October 2, 1995
NRC-95-0104

Subject: Proposed Emergency Technical Specification Change (License Amendment) - Deferral from Limited Aspects of Surveillance Requirements 4.3.3.2, 4.8.1.1.2.e.4.b, and 4.8.1.1.2.e.6.b

**PROPOSED TECHNICAL SPECIFICATION CHANGE
(LICENSE AMENDMENT)**

**ONE-TIME DEFERRAL FROM
LIMITED ASPECTS OF SURVEILLANCE TESTING**

EDG OUTPUT BREAKER CONTROL

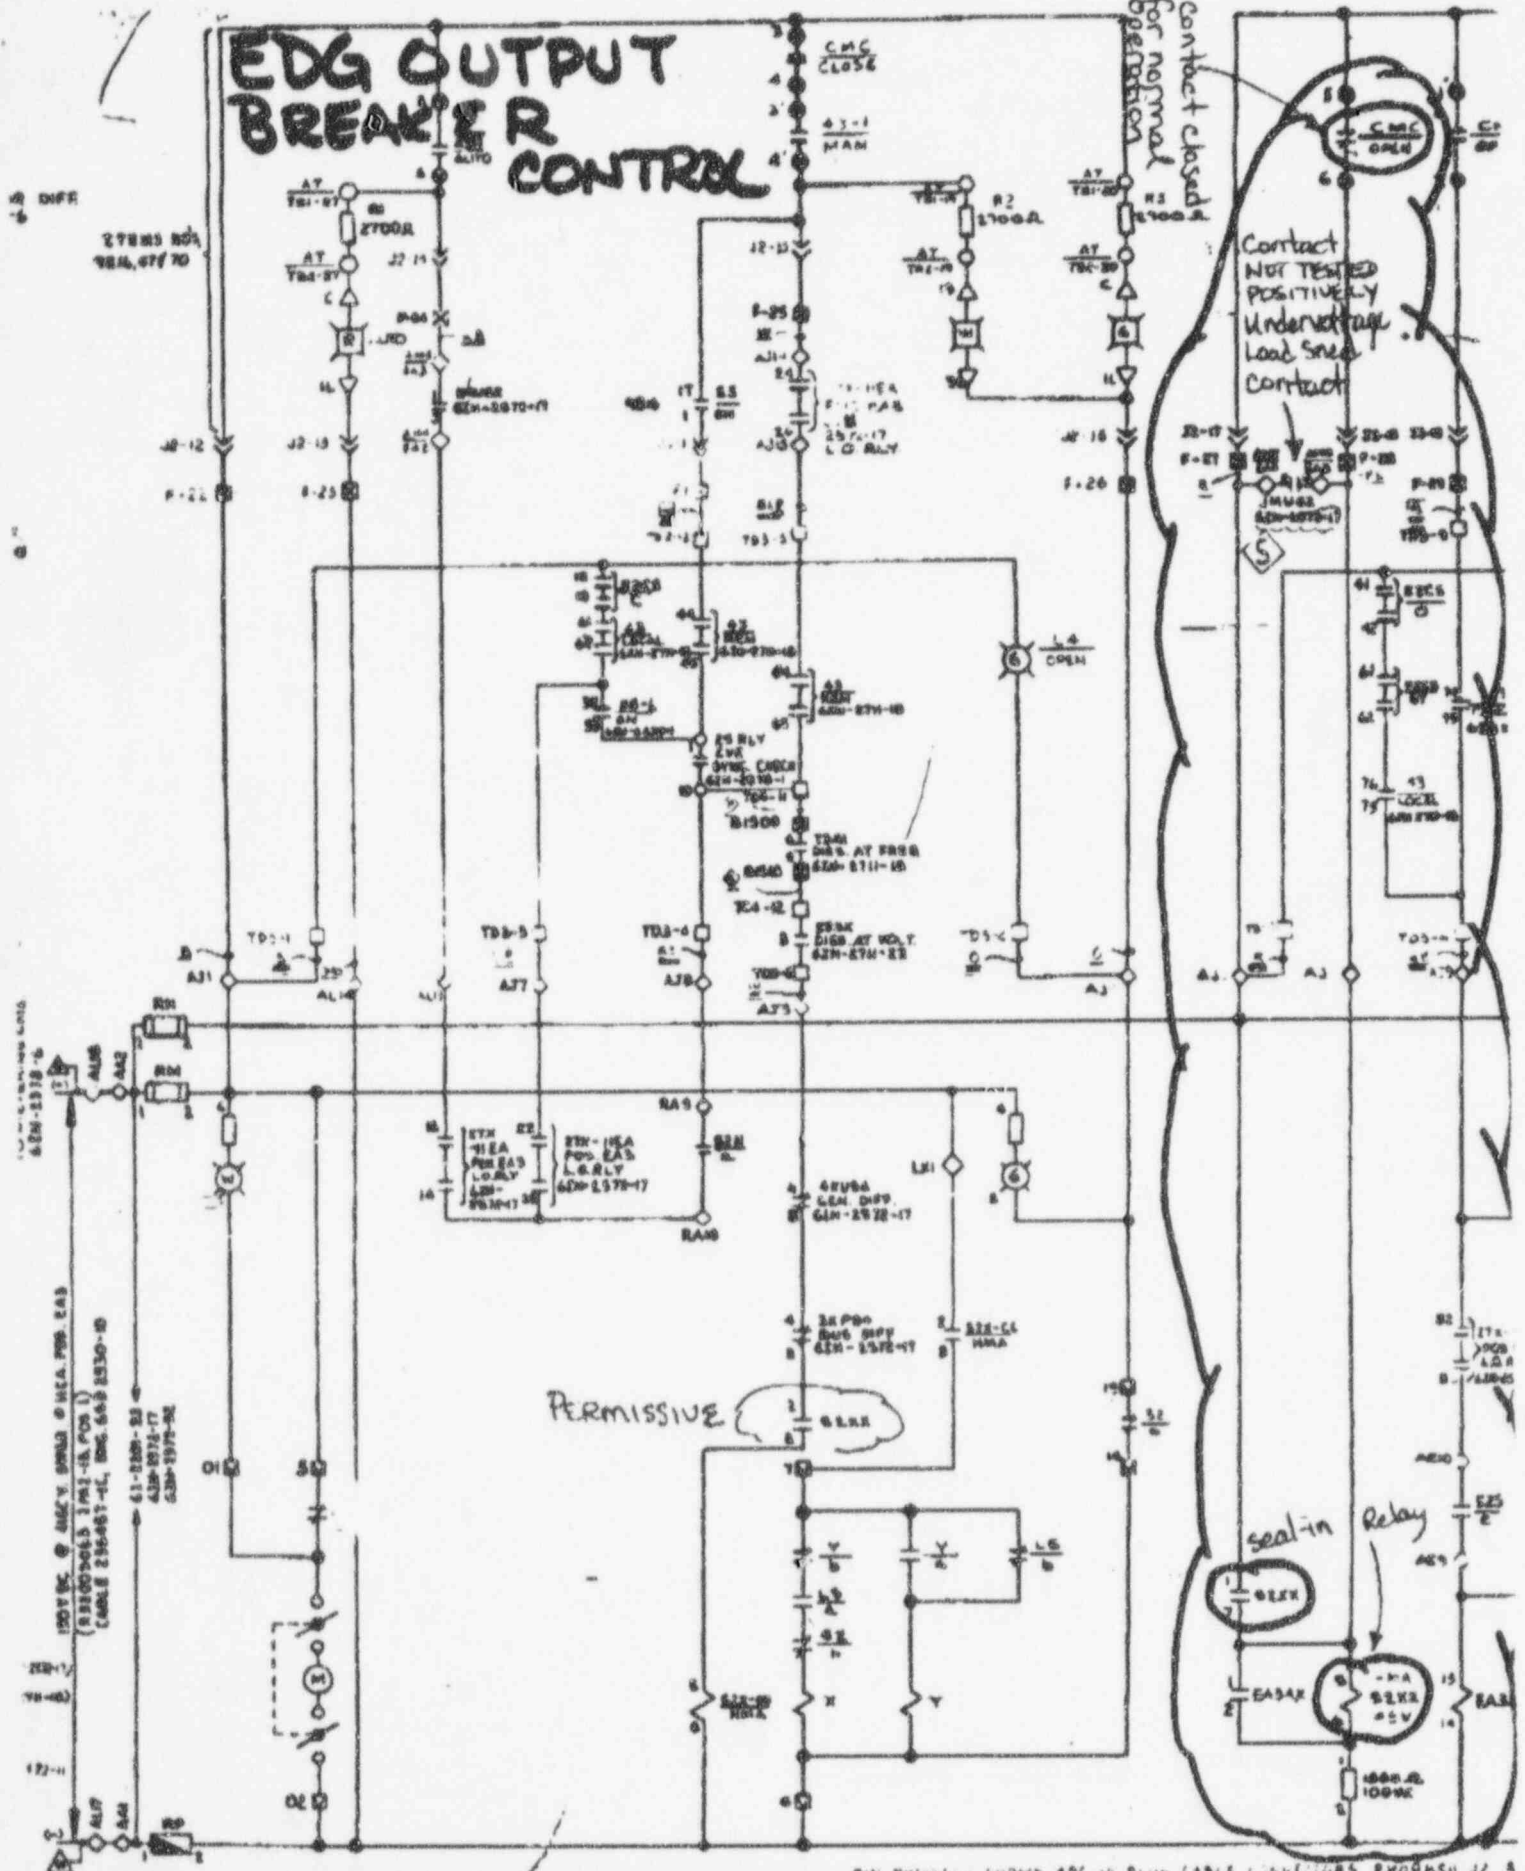
logic contacts close to re-energize the output breaker closing coil permissive relay (relay 52XX). Closure of one of the 52XX relay contacts, coincident with other breaker closure signals, results in closure of the breaker. However, this testing does not verify that the parallel control room breaker closure (CMC) switch contacts, or the 52XX relay seal-in contacts, are not responsible for the re-energizing of the 52XX relay. The surveillance test procedure has the CMC switch in the required position which should result in the associated CMC switch contact being open, and the 52XX relay dropping out, however, there is no positive verification that these contacts are not in fact closed (i.e., stuck). Refer to the attached sketch for a sample schematic representation.

For the testing deficiencies associated with the diesel generator output breaker logic, the function of the inadequately tested contact is not needed (function bypassed) when the output breaker CMC switch is in the OPEN position, the normal plant operations state. Further, any hypothetical failure of the subject contacts could have gone undetected during the surveillance testing only if a parallel contact in the output breaker CMC switch or the 52XX relay had failed closed. If this had occurred, the output breaker would still function as needed because the 52XX relay would energize via the failed closed parallel contact(s) and provide the required breaker closing coil permissive logic.

The 52XX relay provides anti-pumping protection for the circuit breaker. Anti-pumping is a feature of an electrically operated circuit breaker whereby repeated closing and tripping, pumping, is prevented after a breaker closure signal is initiated and the circuit breaker closes into a fault. For the Fermi 2 circuit breakers, a shunt contact is connected across the 52XX relay coil such that the shunt contact closes whenever the circuit breaker closes, thereby shorting out the relay coil causing the relay to drop out. This scenario resets the circuit breaker circuitry in preparation for a circuit breaker reclosure attempt in the event of a loss of offsite power. Therefore, in the event that either the 52XX seal-in contact or the CMC "open" contact are welded in the closed position (i.e., situation

Detroit Edison is proposing that Technical Specification sections 4.3.3.2, 4.8.1.1.2.e.4.b, and 4.8.1.1.2.e.6.b be amended to defer a portion of the logic system functional test surveillance requirements related to emergency diesel generator output breaker re-closure circuitry that is initiated following a load shed, and to defer portions of the emergency 480-volt Motor Control Center (MCC) load sequencer surveillance testing requirements until the next plant outage.

480V LOAD SEQUENCER (TYPICAL)

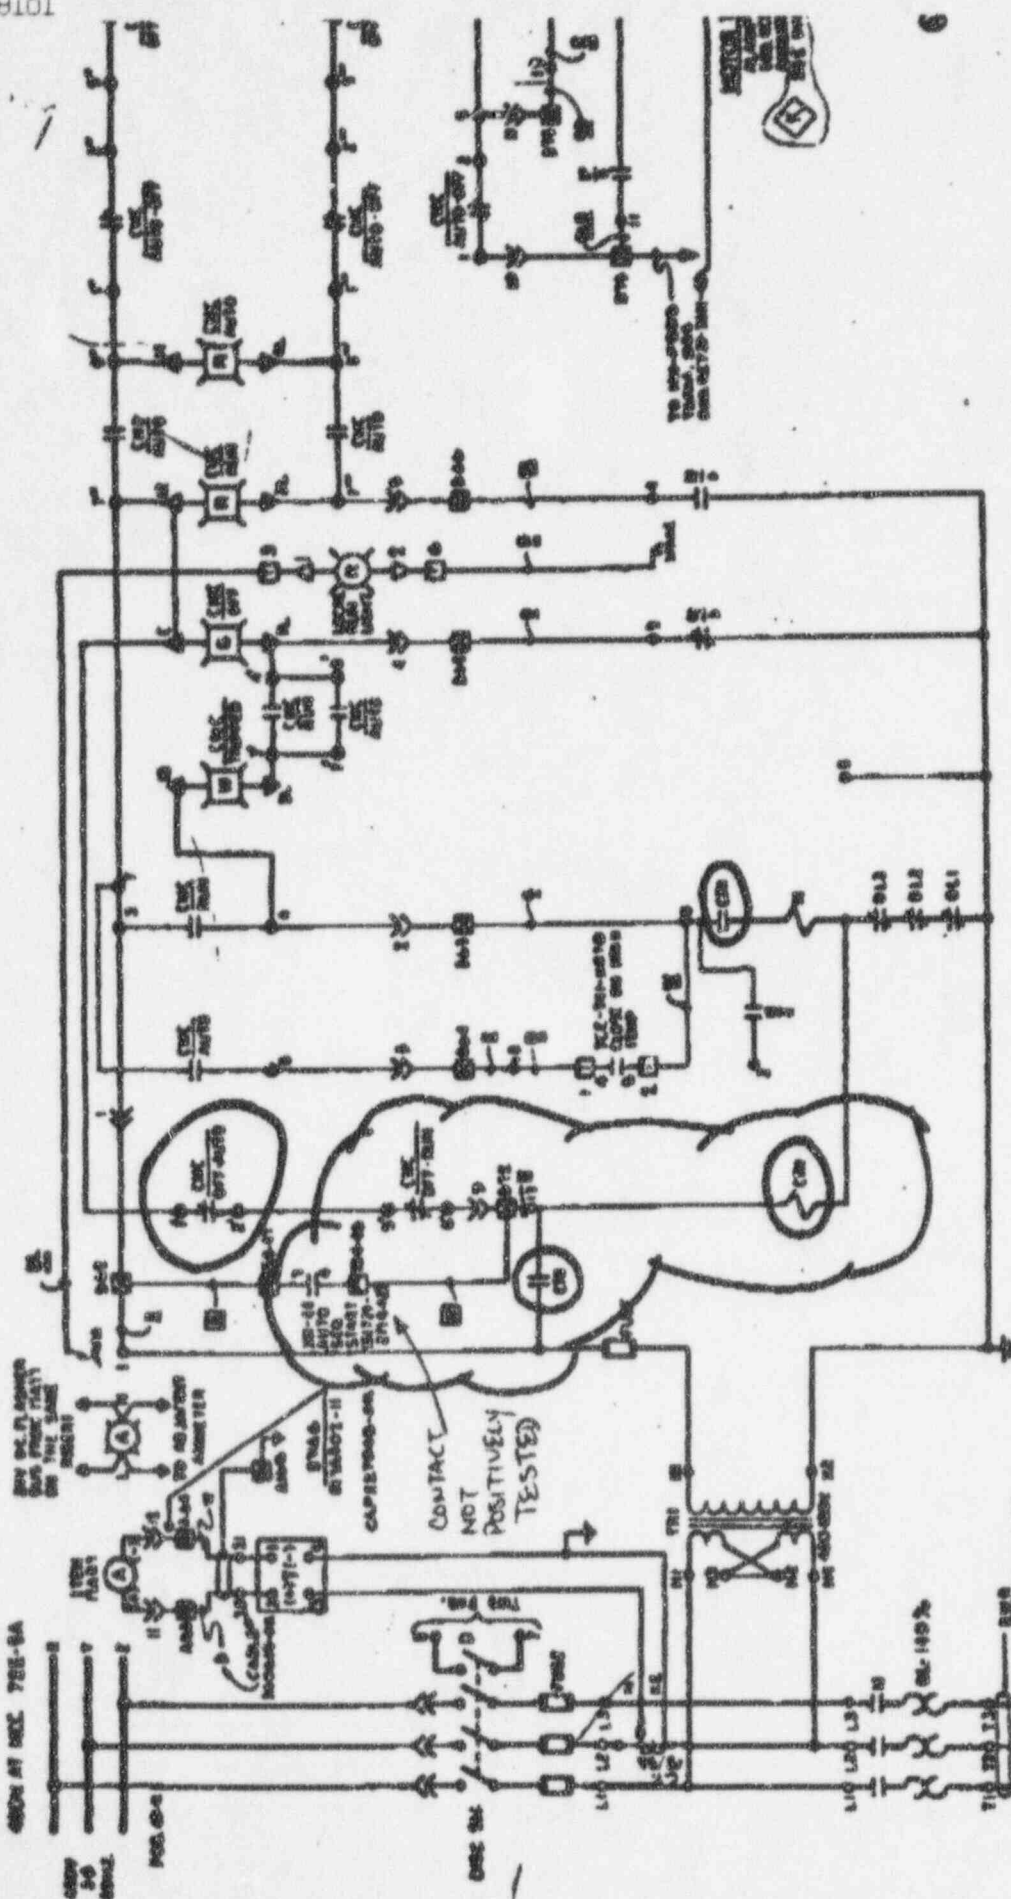
TS Surveillances 4.8.1.1.2.e.4.b and 4.8.1.1.2.e.6.b require verifying that the diesel generator starts on the auto-start signal and energizes the emergency busses with automatically connected loads through the load sequencer. The associated surveillance test procedure involves verification that the auto-connected loads are running on the 480-volt emergency busses after the diesels automatically start. However, this testing does not verify that the automatic digital load sequencer system sequencing relays are responsible for actually closing the associated loads. There are parallel control switch contacts and/or control relay contacts that could provide for immediate connection of the loads to the 480-volt emergency bus after diesel generator starting without a closure signal from the load sequencer system. The sequence of surveillance testing establishes the conditions to open these parallel contacts, but does not include positive verification that the parallel contacts are actually open. Refer to the attached sketch for a sample schematic representation.

For the inadequately tested load sequencer contacts, any hypothetical failure of the subject contacts could have gone undetected during the surveillance testing only if a parallel contact in the associated CMC control switch or control relay contact had failed closed and had not been detected. If this had occurred, the associated load would still function as needed because the logic would be completed via the failed closed parallel contact(s) and the 480-volt emergency bus loads would load onto the bus when the diesel breaker closes. In addition, since the surveillance testing did verify that the diesels were able to respond adequately to the connection of all loads, any failure which had not been detected during previous testing has had no impact on the function of the diesels.

For the 480-volt load sequencers, in the worst case, if one of the parallel contacts was welded closed, the associated load would operate if needed to perform its safety function. The only consequence of a welded closed parallel contact would be that the 480-volt load would be connected to the diesel generator immediately upon closing of the diesel generator output breaker, instead of being delayed in groups by the load sequencer for certain time periods (usually 5 or 10 seconds) after the diesel generator output breaker closes.
